Omaha Public Power District

Reference: Docket No. 50-285

FORT CALHOUN STATION

RESPONSE TO NRC SETPOINT
METHODOLOGY QUESTIONS

Figure 1.1

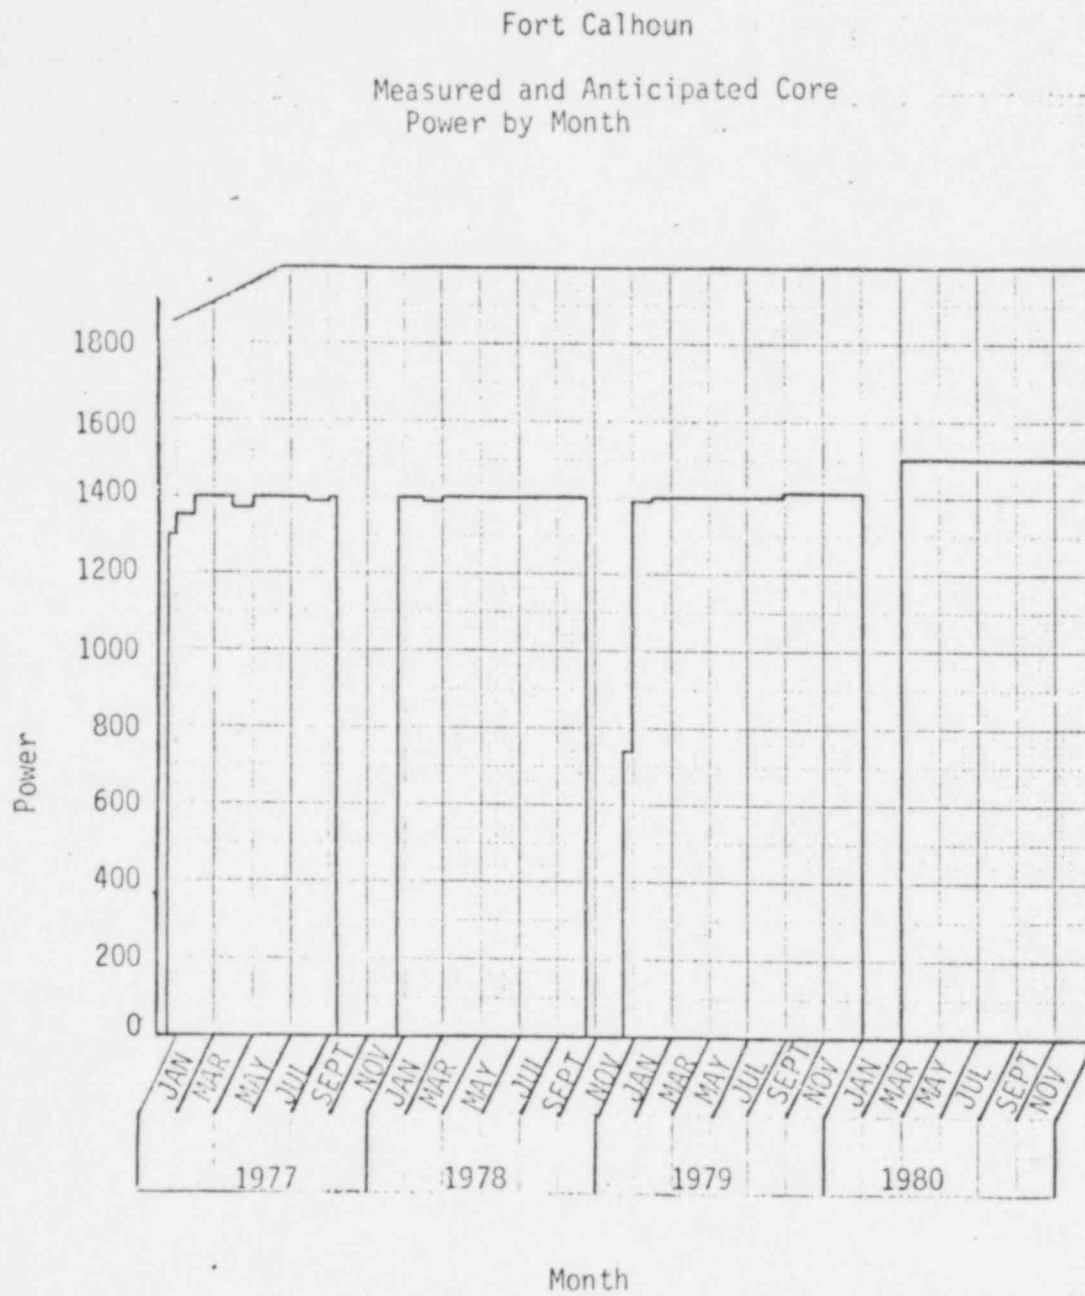
List all operational maneuvers or conditions considered in generating axial power shapes. Also list the control rod configuration and burnup. Describe how the Xenon oscillations were induced.

Also describe whether the plant was base loaded or in a load follow configuration. Give the power history assumed. This information may be provided most efficiently in matrix form.

Justify that only these maneuvers need be considered for generating axial power shapes.

For Ft. Calhoun Cycle 6, how many axial power shapes were generated and how many were used in the set point analysis?

The Fort Calhoun Cycle 6 core was modeled in three-dimensions with the computer code XTG⁽¹⁾ and depleted in a base load (1500 MWt) all rods out configuration. This reference power history and rod configuration for Cycle 6 was chosen based on the power and control rod histories of previous cycles (Cycles 3, 4, and 5) and OPPD's anticipated operating requirements for the Fort Calhoun Nuclear Power Plant throughout Cycle 6. (The plant is currently finishing up the 5th cycle.) A bar chart showing the actual plant power and control rod configuration by month for Cycles 3, 4, and 5 and the anticipated power and rod histories assumed in the analysis for the determination of Cycle 6 setpoints are shown in Figures 1.1 and 1.2.
